**CERTIFICATE OF APPROPRIATENESS**

**Property:** 2117 Lubbock Street, Lot 11, Tract 10A, Block 408, Baker W R Neighborhood Subdivision. The property includes a historic 1,289 square foot, one-story wood single-family residence and detached garage situated on a 5,500 square foot (55' x 100') interior lot.

**Proposal:** Alteration: Two-story rear addition

Current Photo – North Elevation

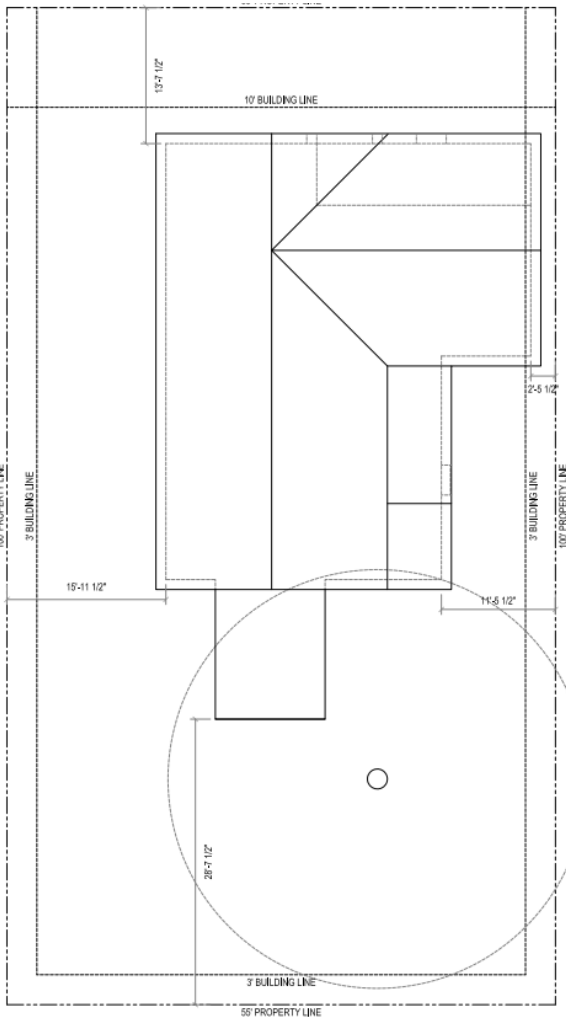
Front door relocation has already been done. From Google Street view, alteration made between Oct. 2018 and Nov. 2019

**Existing Front (North) Elevation**

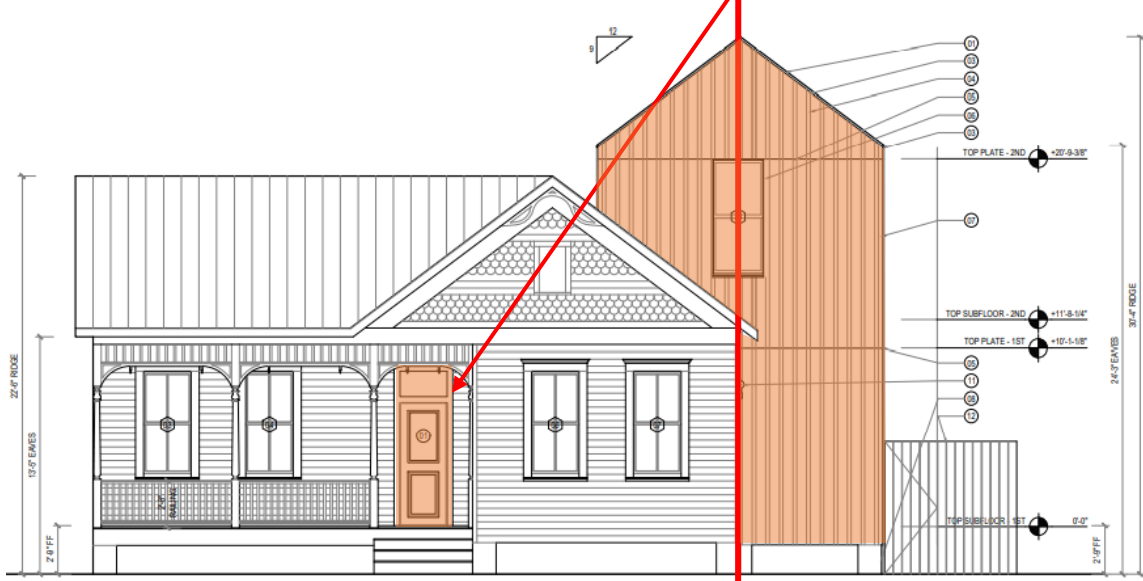
Front door relocation has already been done. From Google Street view, alteration made between Oct. 2018 and Nov. 2019
